From: Mike Raynor [REDACTED]
Sent: 11 November 2021 10:49
To: David Easton <David.Easton@arun.gov.uk>; Planning <Planning@arun.gov.uk>
Cc: [REDACTED] Tony Kirby [REDACTED] Steven Windass
[REDACTED] Philip Atkinson [REDACTED] Paul McLaughlin
[REDACTED]
Subject: F/5/20/PL - Ford Airfield Market - Objection Letter

Application Ref.: F/5/20/PL
Applicant: Ford Airfield Market
Proposal: Reconfiguration of Ford Market, including revised market access, hardstanding for replacement vehicular parking and associated infrastructure, landscape, ancillary and site preparation works.
Location: Ford Airfield Market, Ford, BN18 0FL

FORD ENERGY RECOVERY FACILITY AND WASTE SORTING AND TRANSFER FACILITY, FORD CIRCULAR TECHNOLOGY PARK STAGE 1 ROAD SAFETY AUDIT RESPONSE REPORT

FORD ENERGY RECOVERY FACILITY AND WASTE SORTING AND TRANSFER FACILITY, FORD CIRCULAR TECHNOLOGY PARK STAGE 1 ROAD SAFETY AUDIT REPORT

FORD ROAD/ ACCESS ROAD
VEHICLE TRACKING
(ARTICULATED TRUCK - 16.5m)

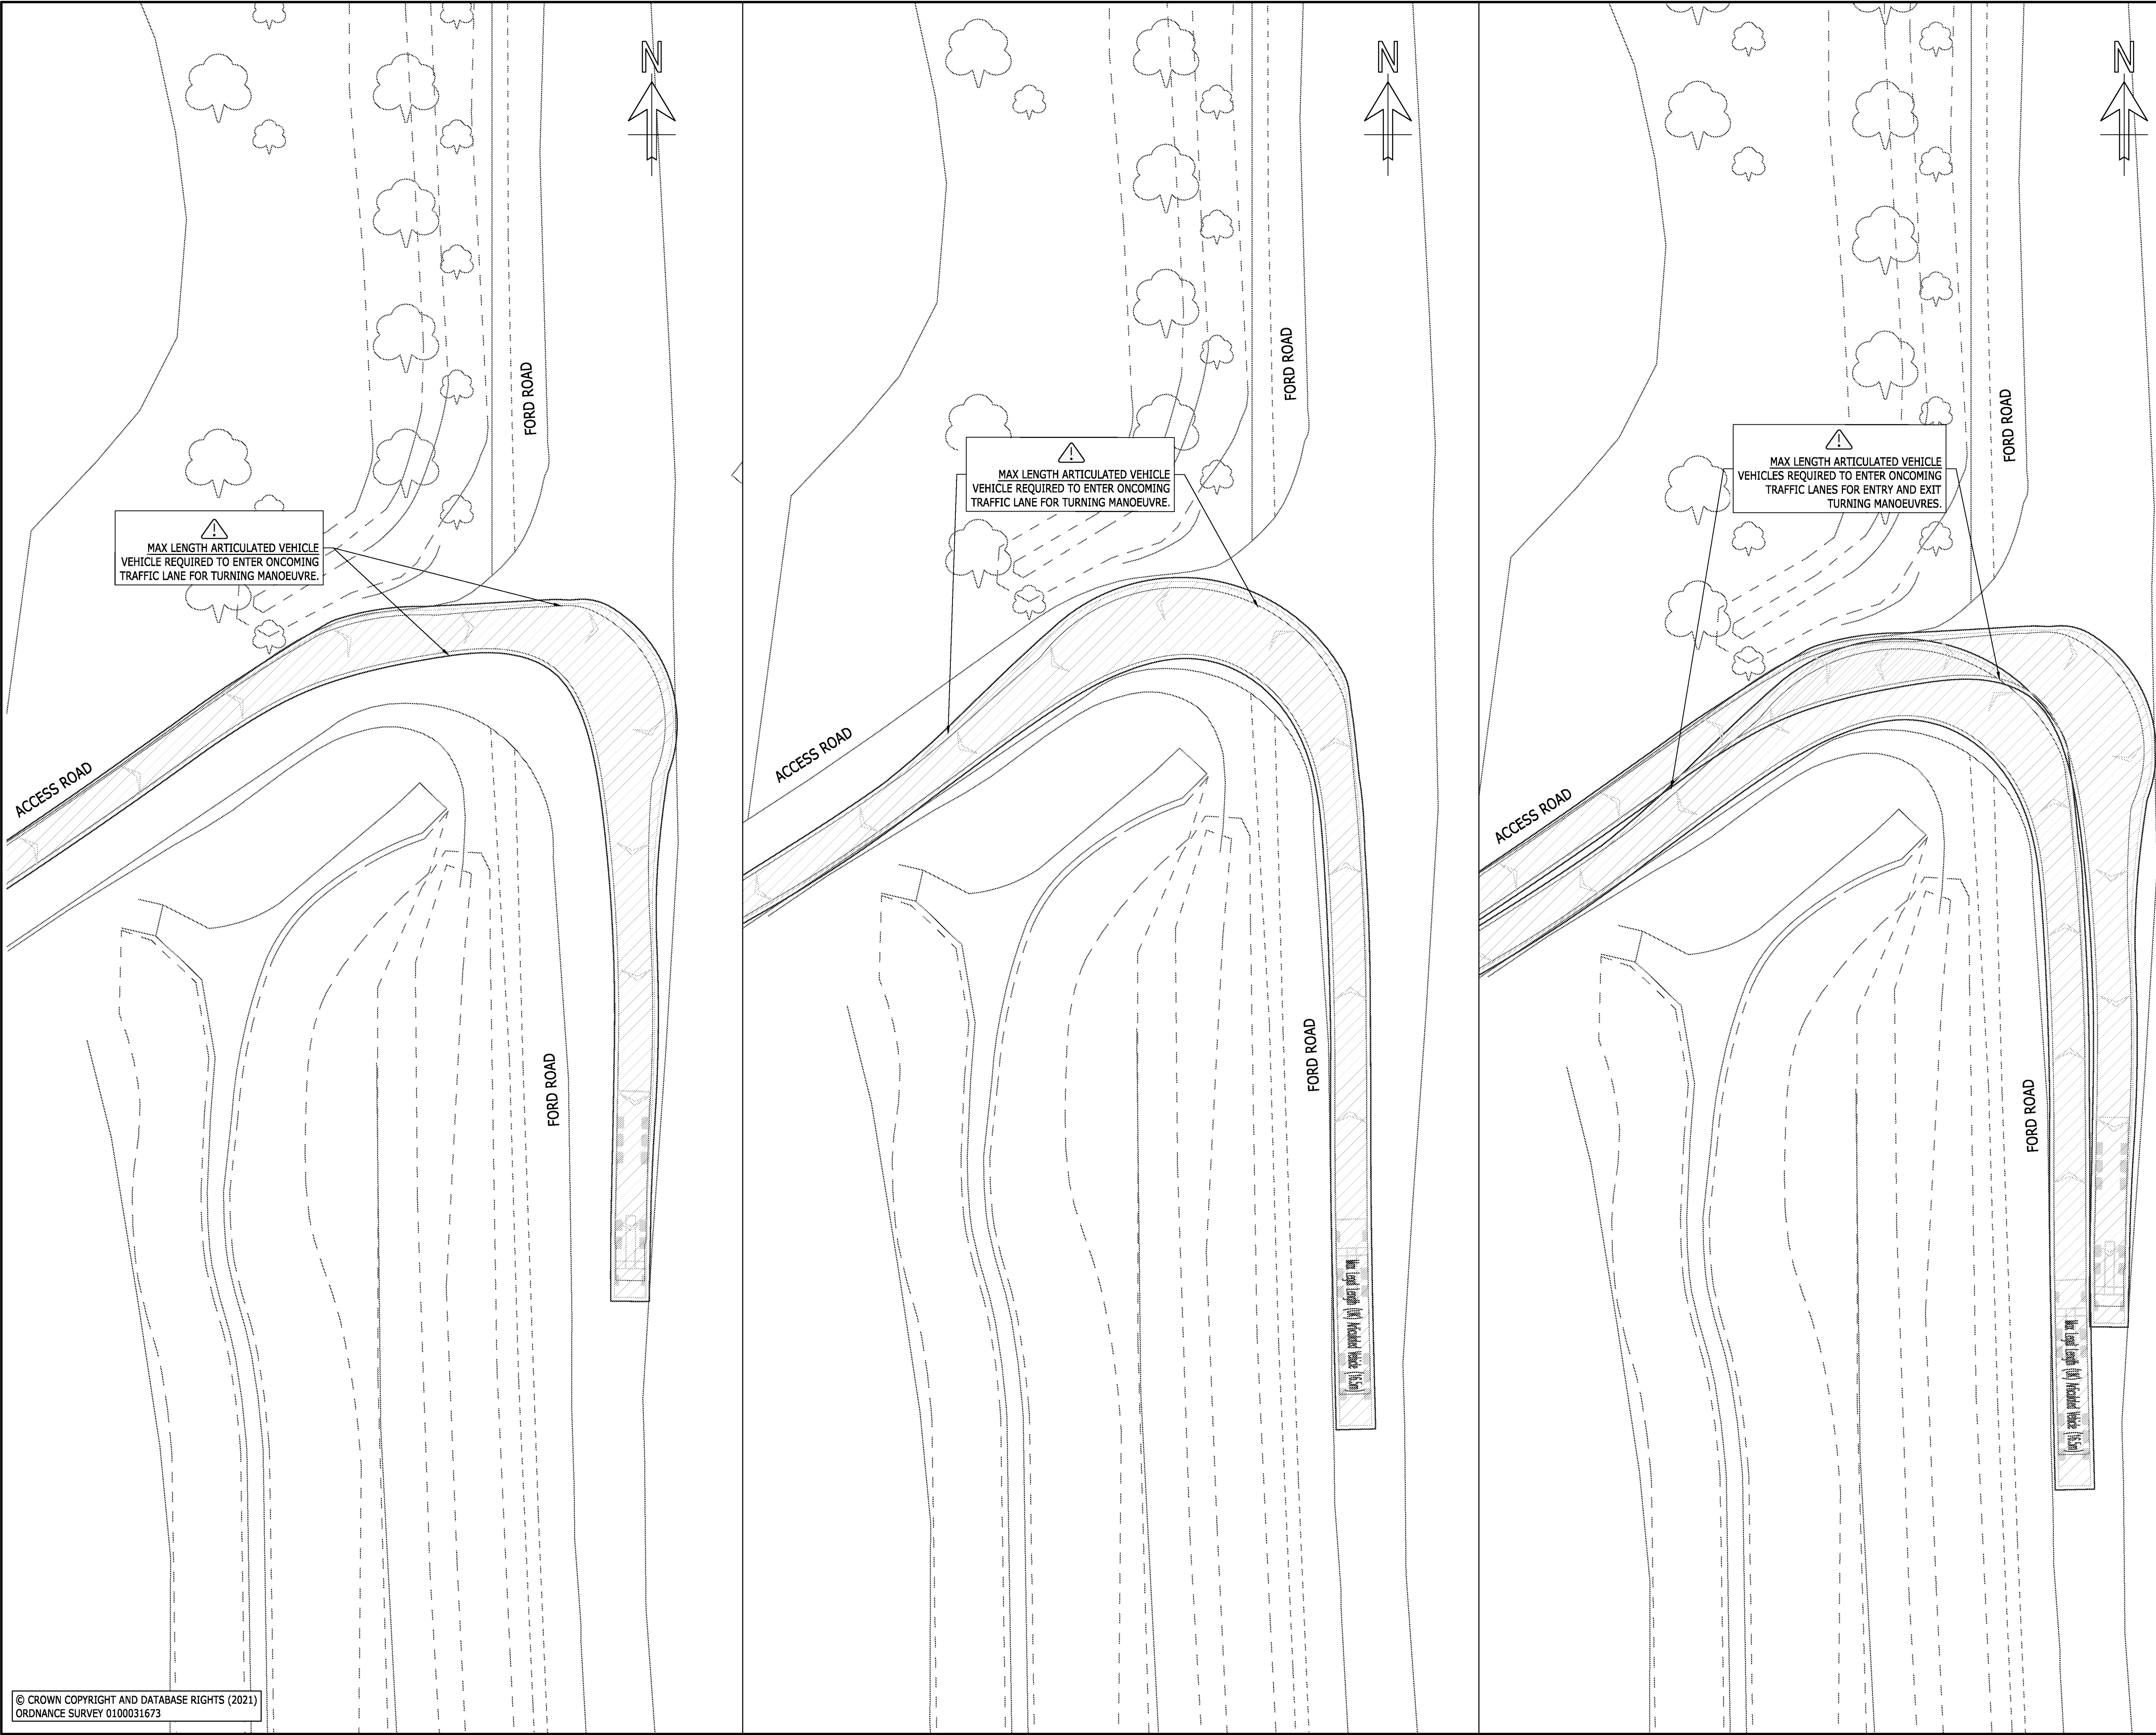
The outstanding issue relates to the movement of Heavy Goods Vehicles (HGVs) accessing the site from the south and requiring the full width of the existing access road to turn left into the site as demonstrated in the Swept Path Analysis (SPA) appended to this objection letter. As shown in the SPA, this impacts all vehicles utilising the existing access road should a vehicle be waiting at the access junction to turn left/right out of the site.

It is accepted that the existing HGV turning movements, namely left into the access and right out of the access on Ford Road, results in HGVs encroaching onto the opposite side of the access road carriageway due to the existing geometry of the Ford Road access junction, with limited scope to widen the junction within the extents of the adopted highway boundary.

As part of the EfW application, WSCC Highways subsequently requested that a junction widening scheme at the existing access junction on Ford Road was required to enhance the turning movements of Heavy Goods Vehicles (HGVs) to/from the south on Ford Road (left in and right out) which would form a pre-occupation planning condition. The current stance from WSCC Highways in relation to the EfW application is that *'it has not been demonstrated that the development would not have an adverse impact on the safety of all road users'*.

HGV + PRIVATE CAR
VEHICLE TRACKING
SKETCH

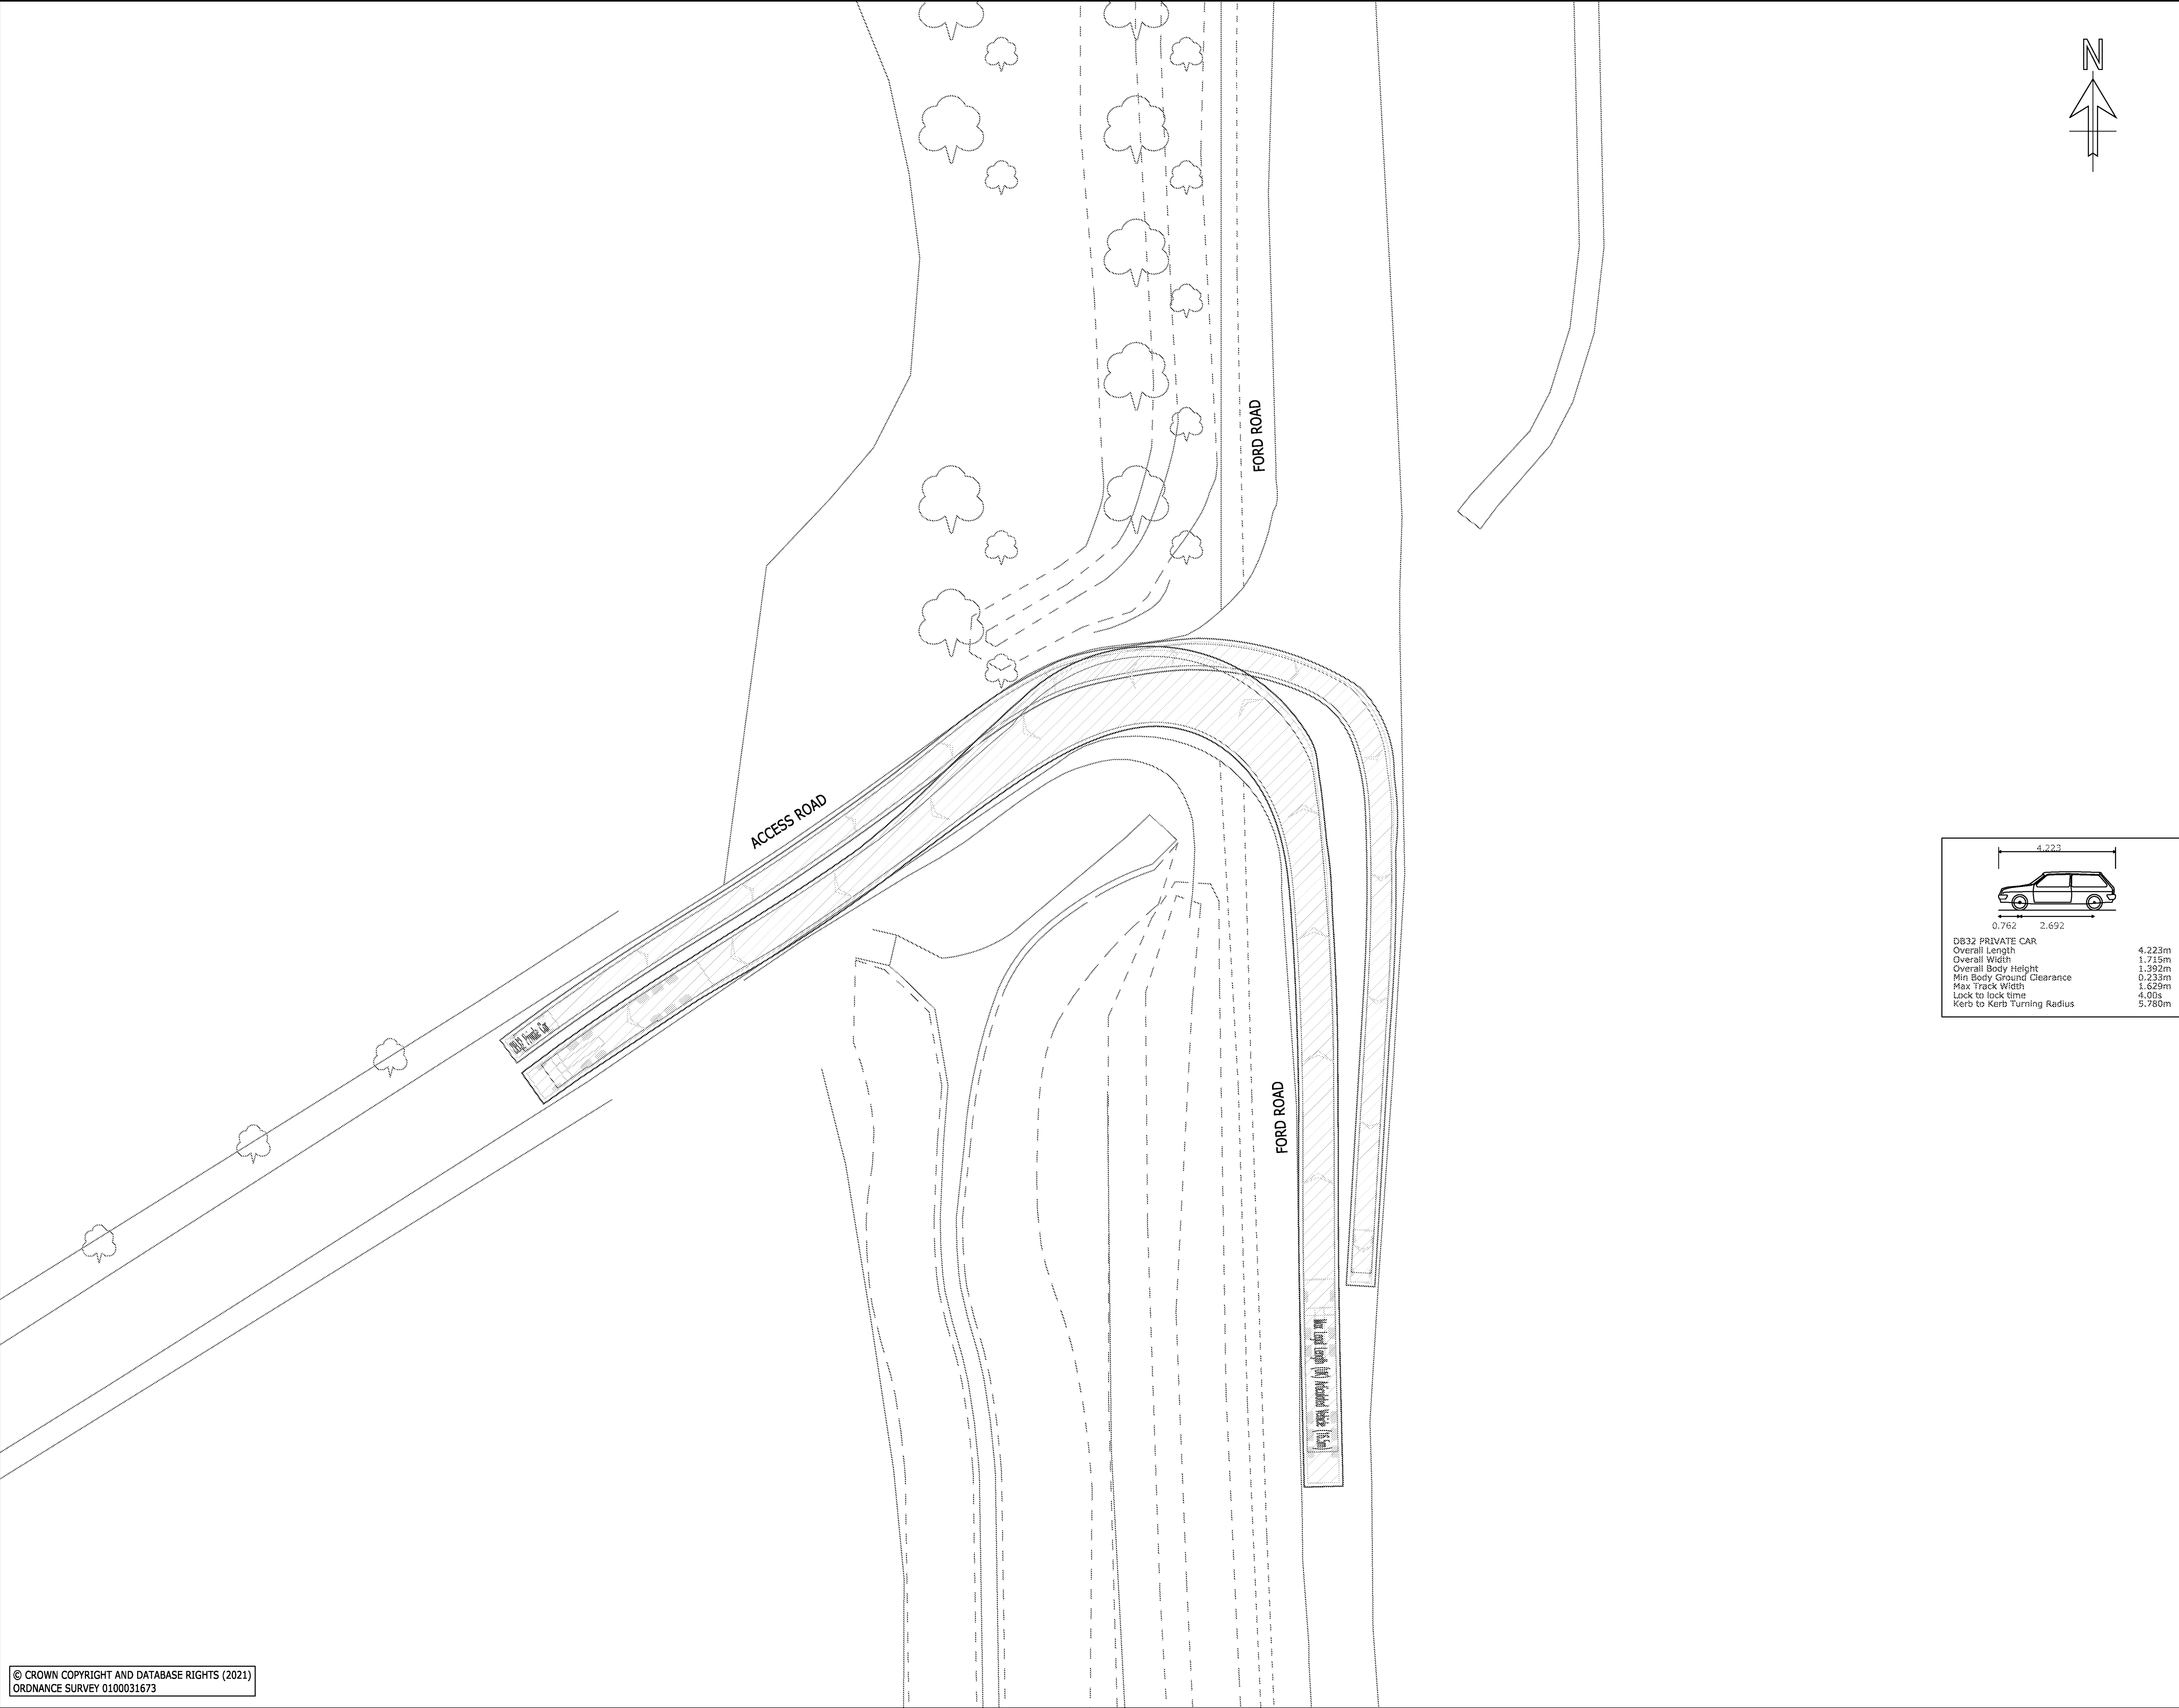
Even if a single car associated with the market is waiting at the access to turn out onto Ford Road this means that the HGV arriving on Ford Road will have to wait before entering the access road. This has the potential to impact the free-flow of vehicles and cause operational/road safety issues on Ford Road. Therefore, it is considered that the junction widening scheme is also required to facilitate the revised market operation.

Photo D Ponding of water on site access road

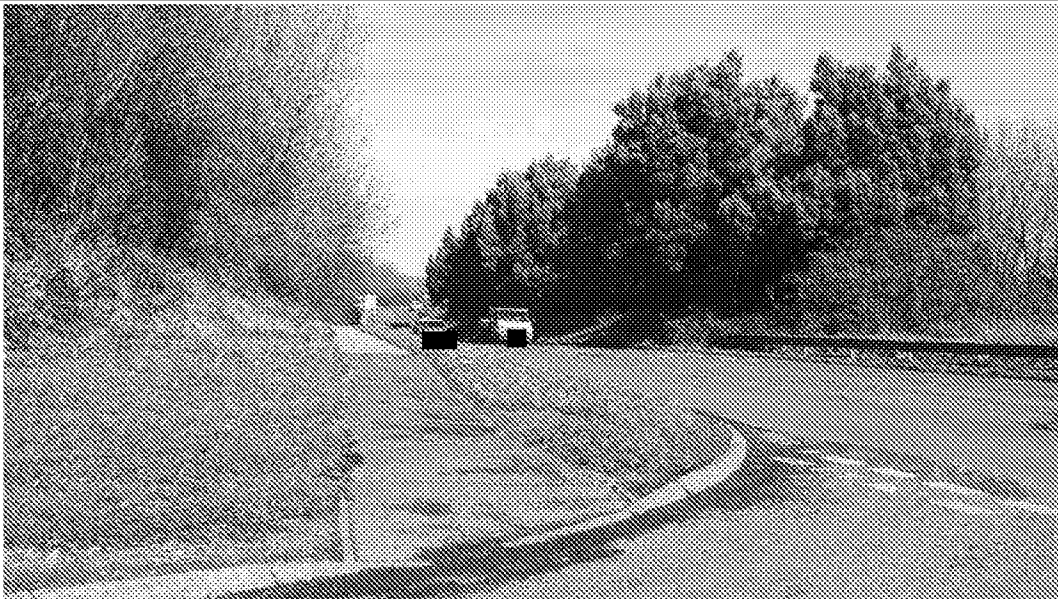
RSA PROBLEM	RSA RECOMMENDATIONS	DESIGN ORGANISATION RESPONSE	OVERSEEING ORGANISATION RESPONSE	AGREED RSA ACTIONS
Location North channel of site access road (Problem Location C, Appendix A refers) Summary Ponding of water encroaching onto carriageway Details Despite the weather being sunny and warm with no obvious evidence of recent rain, during the site visit the Auditors noted ponding of water in the north channel of the site access road, close to the junction. The types of collisions that may occur if vehicles encounter such ponding is loss of control, either due to water in spring, summer or autumn, or due to ice in winter.	Install drainage system to deal with surface run-off and discharge away from road and nearby footway.	It is likely this issue is related to maintenance of roadside drainage systems (a blocked gully, an outlet silted up, etc.). The Designer requests WSCC to share its forward programme of drainage renewals to assist in responding to the RSA recommendation. If the drainage system in question is not owned by WSCC, the Designer will request the appropriate landowner to attend to the maintenance required.

Location: North channel of site access road (Location C on Plan in Appendix 2)
